PROJECT SCOPING PLAN FOR PERFORMING A
CERCLA REMEDIAL INVESTIGATION/FEASIBILITY
STUDY (RI/FS) AT THE MUNITIONS WASHOUT FACILITY
AND LEACH FIELD, SENECA ARMY DEPOT ACTIVITY

OCTOBER 1996

**PROJECT SCOPING PLAN
REMEDIAL INVESTIGATION/FEASIBILITY STUDY
AT SEAD-4
SENECA ARMY DEPOT ACTIVITY
ROMULUS, NEW YORK**

**Parsons Engineering Science, Inc.
Prudential Center
Boston, Massachusetts**

PARSONS ENGINEERING SCIENCE, INC.		
CLIENT/PROJECT TITLE		
SENECA ARMY DEPOT ACTIVITY RI/FS PROJECT SCOPING PLAN SEAD-4, MUNITIONS WASHOUT FACILITY LEACH FIELD		
DEPT.	Dwg. No.	
ENVIRONMENTAL ENGINEERING	727651-02004	
FIGURE 3-7		
GROUNDWATER ELEVATION MAP		
SCALE	DATE	REV
1" = 200'	JUNE 1996	A

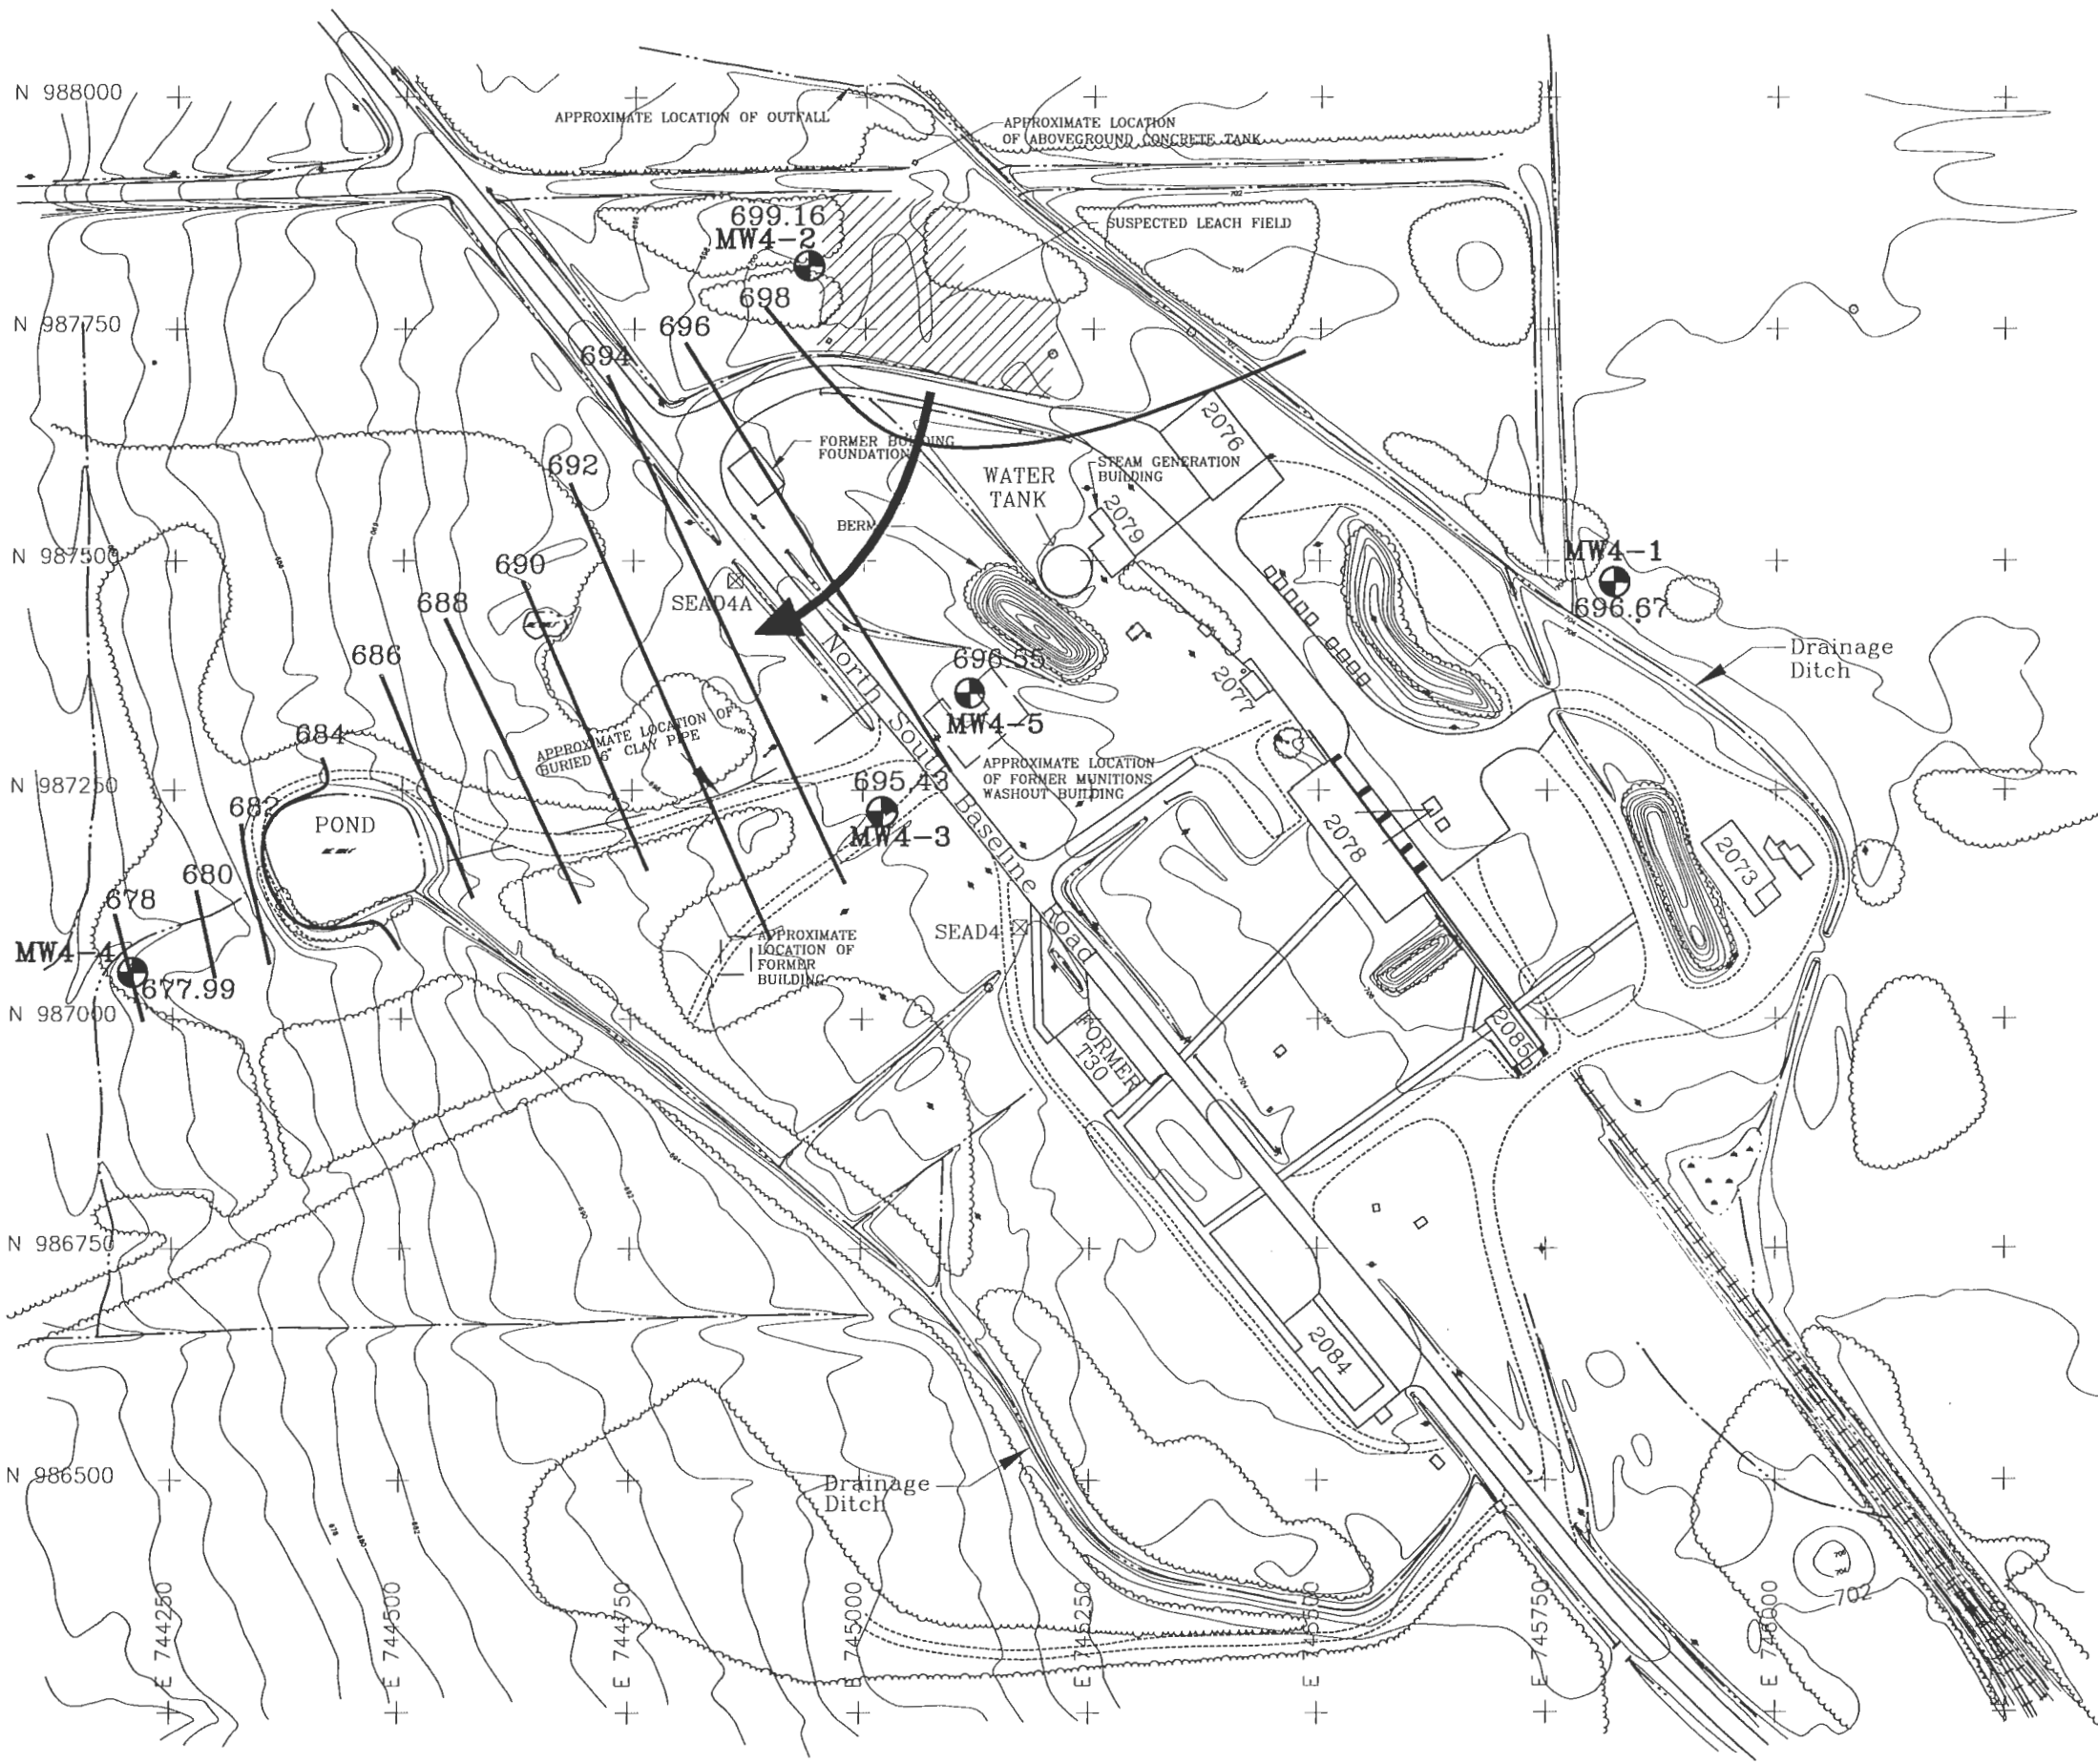
Comment #3 Figure 3-7: The data presented on this figure have been rounded to the nearest tenth of a foot. However, the data presented in Table 3-1 is shown to the nearest 0.01 feet. The data presented in the figure should be the same as shown in the table and the contouring should be checked.

Response #3 Agreed. The data presented on Figure 3-7 has been changed to the nearest 0.01 feet, as shown in Table 3-1.

FIGURE 3-8
SAMPLE LOCATIONS FOR EXPANDED
SITE INSPECTION

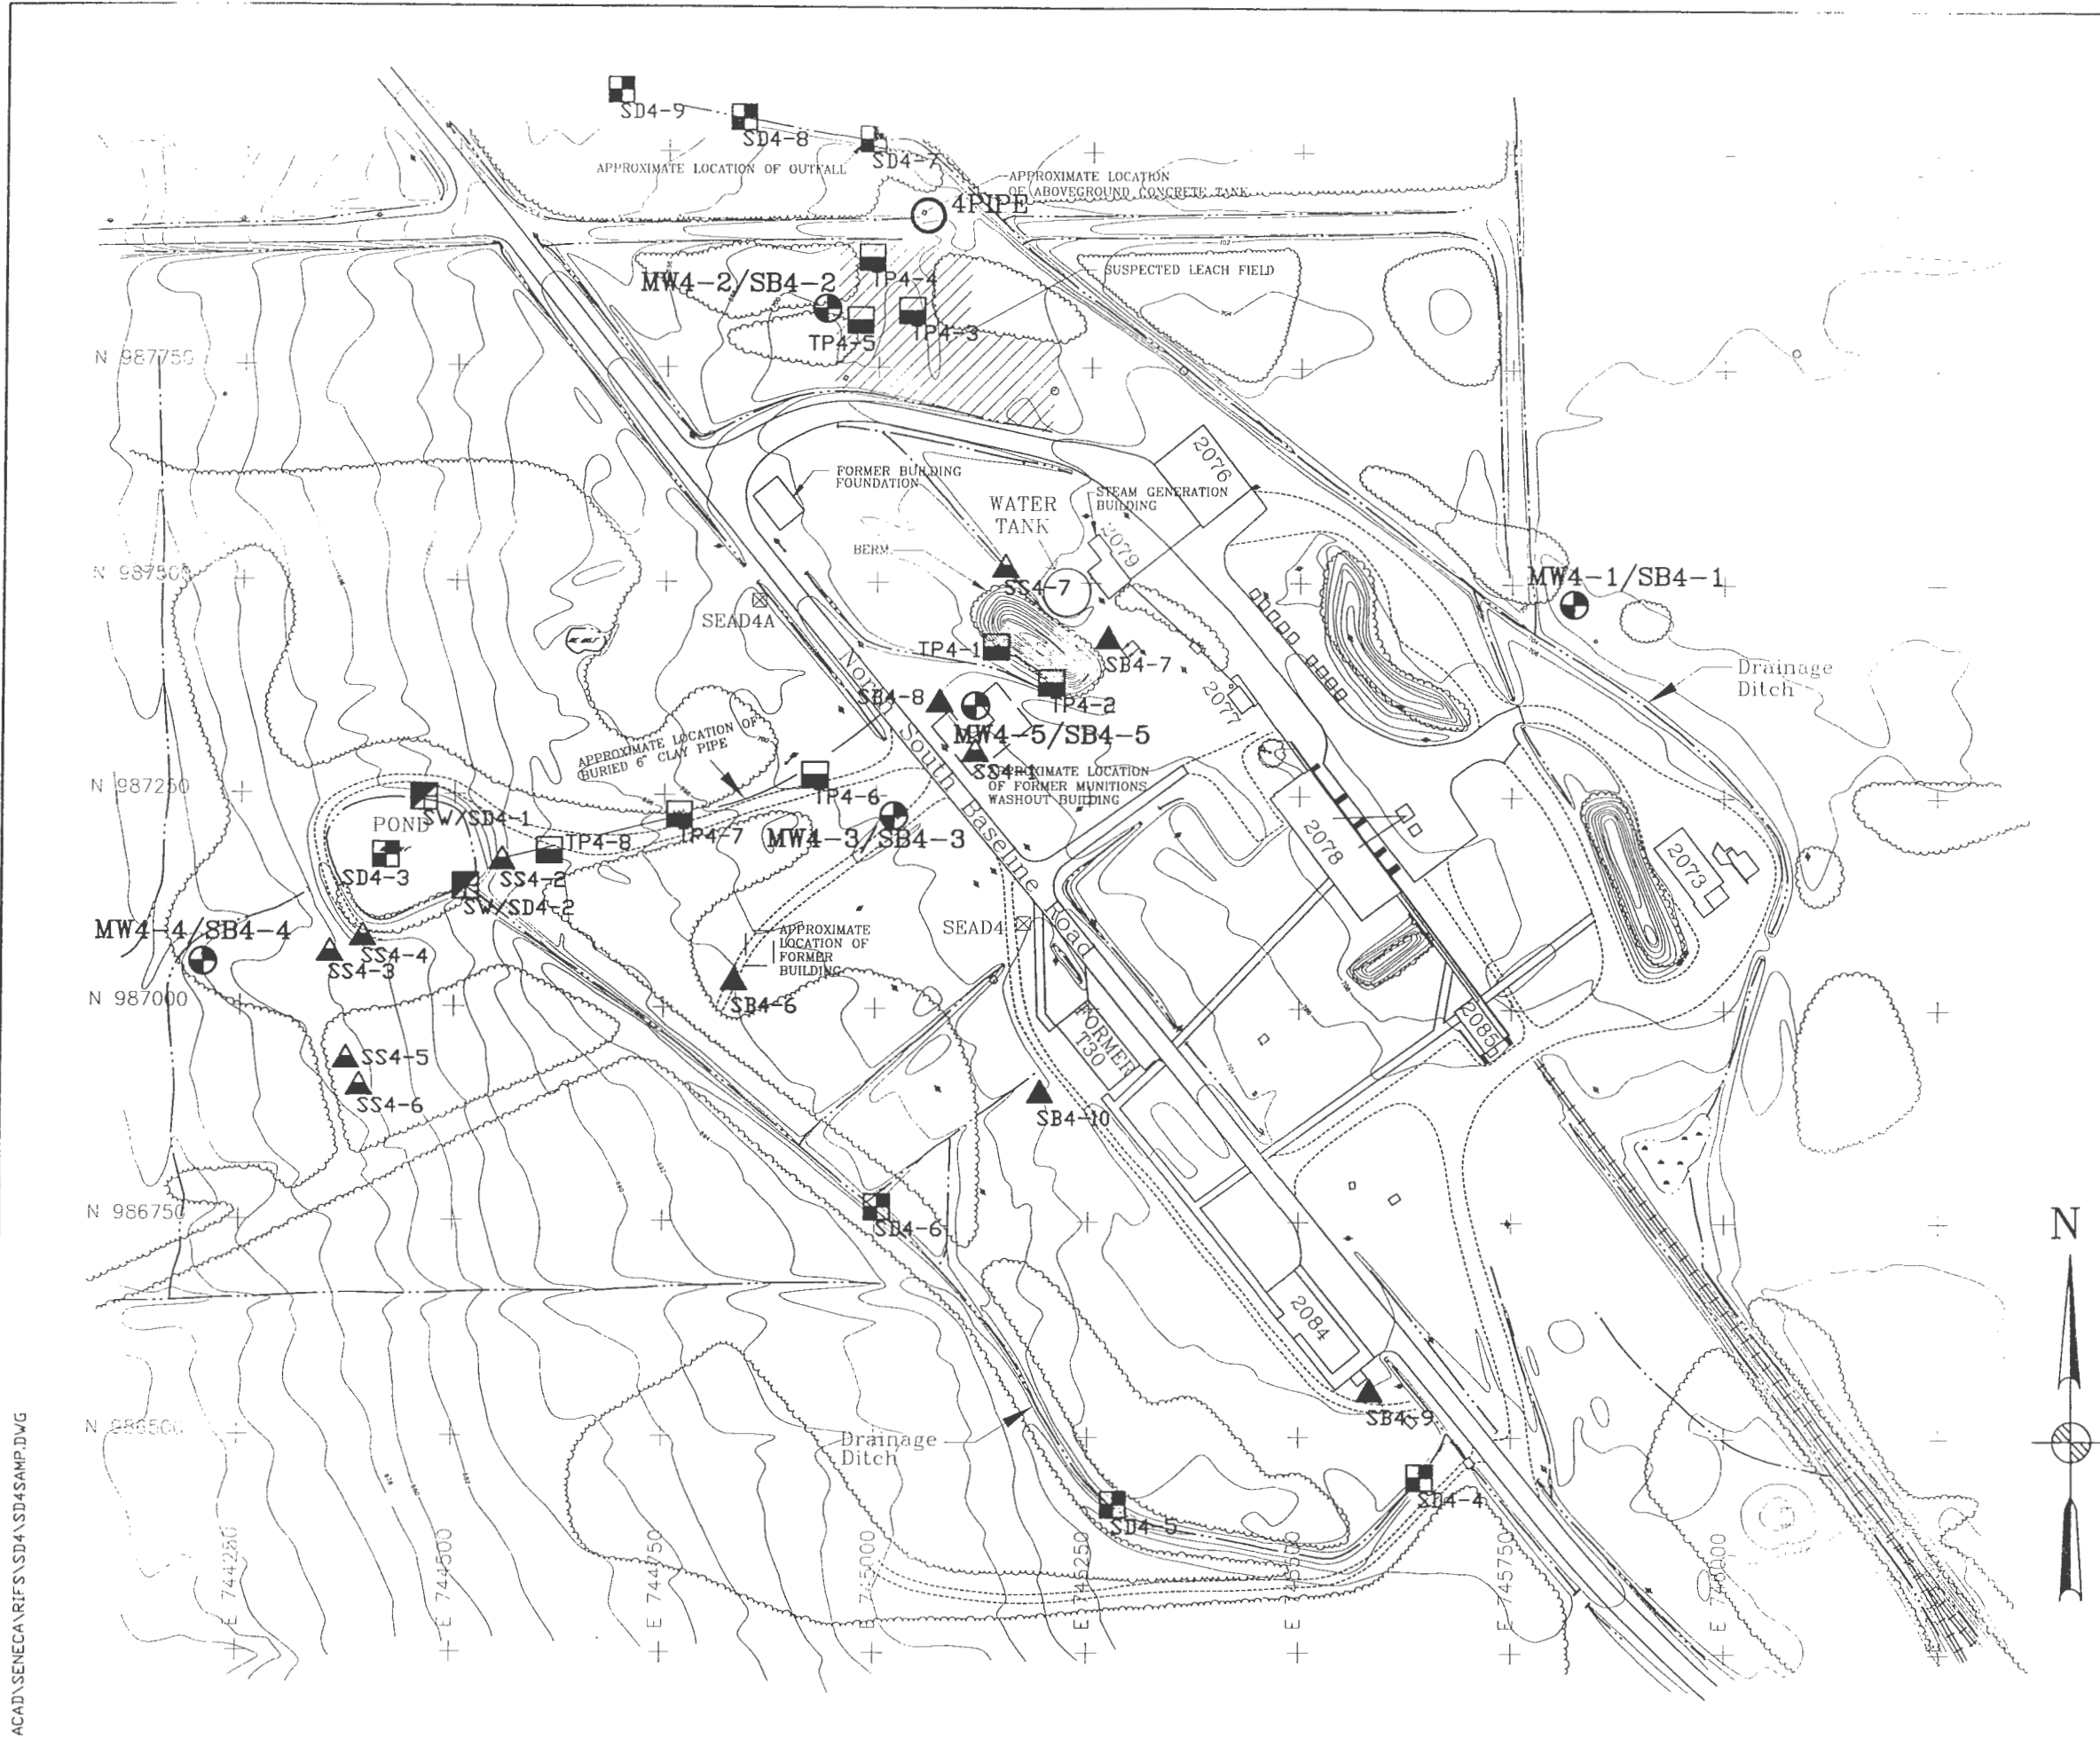
Comment #4 Figure 3-8: The symbol presented for the surface water/sediment sampling locations is not consistent between the legend and the main body of the figure. The sampling location SB4-1, was not found on the figure.

Comment #4 The location of SB4-1, the soil background sample, should be shown in Figure 3-8, "Sample Locations for Expanded Site Inspection."

Response #4 Agreed. The symbol for the surface water/sediment sampling locations (SW/SD4-1 and SW/SD4-2) was refined so that it is consistent with the symbol used in the legend. Also, the borings SB4-1 through SB4-5 were identified on Figure 3-8; they are associated with wells MW4-1 through MW4-5.

Response #4 Agreed. The location of SB4-1 has been added to Figure 3-8.

- Response #4** Agreed. The circle labeled GW4-1 is a vertical pipe that was found to be located directly to the north of the suspected leach field. It is referred to as 4PIPE in the text on page 3-38 of the Final Scoping Plan for SEAD-4. The label for the vertical pipe, which now reads GW4-1, has been changed to 4PIPE on Figure 3-8.
